Joint Panel Report
EUB Decision 2004-009

Shell Canada Limited

Applications for an Oil Sands Mine, Bitumen Extraction Plant, Cogeneration Plant, and Water Pipeline in the Fort McMurray Area

February 5, 2004

Figure 1. Shell Jackpine Mine and surrounding area

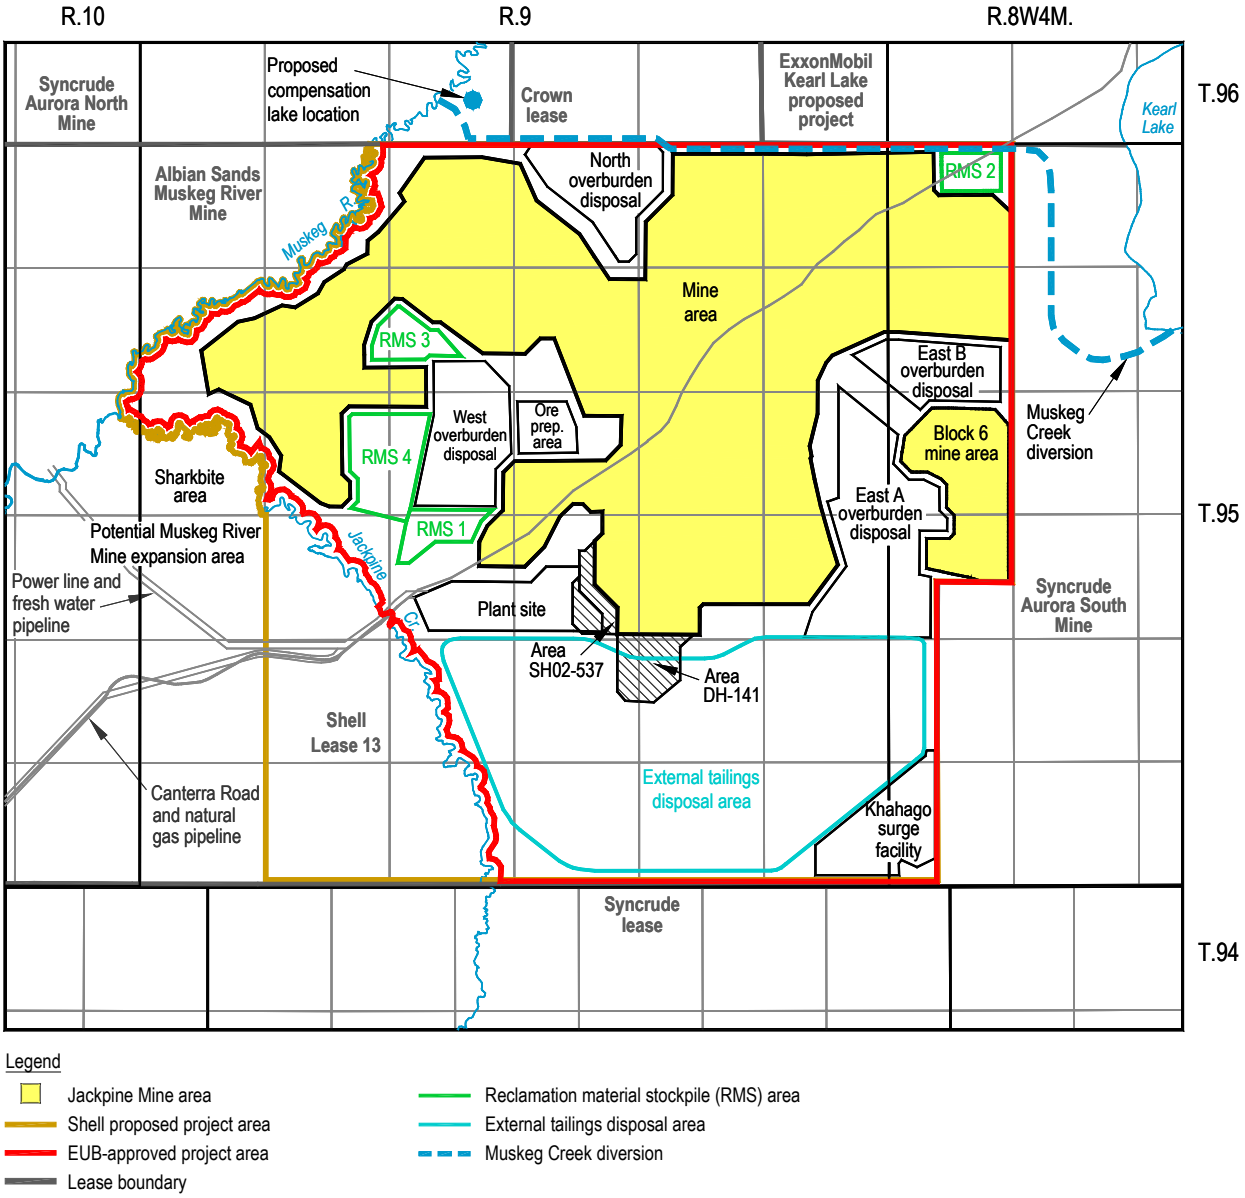
A marginal pit expansion area, denoted as SH02-537, would encroach on the plant site footprint. Shell's evaluation indicated that area was not economic to mine (Figure 1). However, Shell stated that it would complete additional resource drilling along the pit limits in the area prior to finalizing the footprint limit of the plant site.

Shell identified a marginal mining area, denoted as area DH-141, which encroached on the northwest corner of the tailings disposal area, but stated that this area was not economical to mine. Shell stated that while it did not provide the results of combining area DH-141 and SH02-537, work that was completed resulted in a higher combined TV:BIP value than that of either of these pit extensions on their own. SH02-537 was a marginal zone that encroached on the plant site. Shell said that it would complete drilling along the pit limit near the plant site and tailings disposal area prior to finalizing the footprint of either of the sites (Figure 1).

The Panel believes that the plant site footprint is sufficient for the proposed project. However, the Panel will require Shell to obtain EUB approval should the plant site area need to be larger. The Panel directs Shell to submit, for EUB approval, a resource assessment of the plant site area two years prior to construction.

Figure 2. Muskeg River watershed

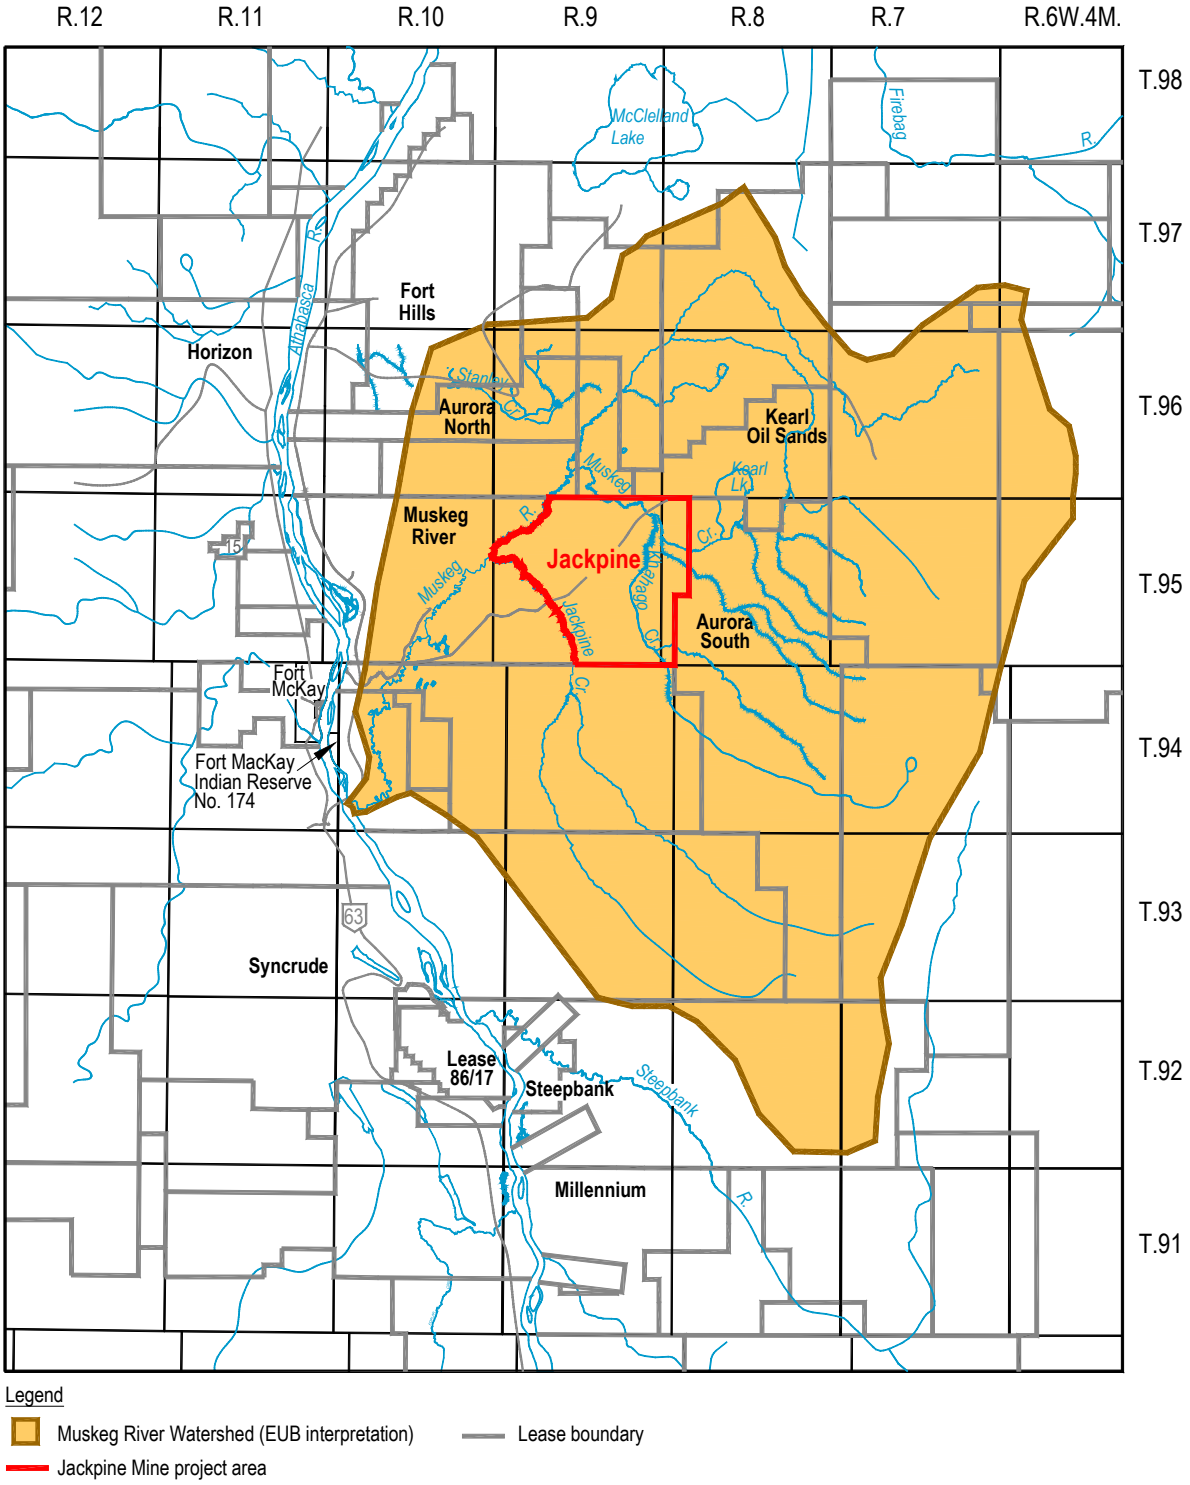
Shell studied seven creek diversion alternatives representing the technically viable options for each creek (see Figure 2). The Khahago, Muskeg, Wesukemina, Shelley, Pemmican, Green Stocking, and Blackfly Creeks would be affected in the project area.

Shell stated that several tributary streams of the Muskeg River would be disturbed or excavated during the course of the project. Figure 2 shows the area of the Muskeg River drainage basin and some tributaries of the Muskeg River. Surface waters from seven tributary streams of the Muskeg River would be affected by mining. A new outlet to Kearl Lake and the Khahago surge facility would be constructed. Jackpine Creek would remain essentially unchanged, as it had high value for fish habitat. At mining closure, three large EPLs were planned, two of which would contain water-capped tailings. The lakes would function for flow attenuation and bioremediation of flows from reclaimed lands.
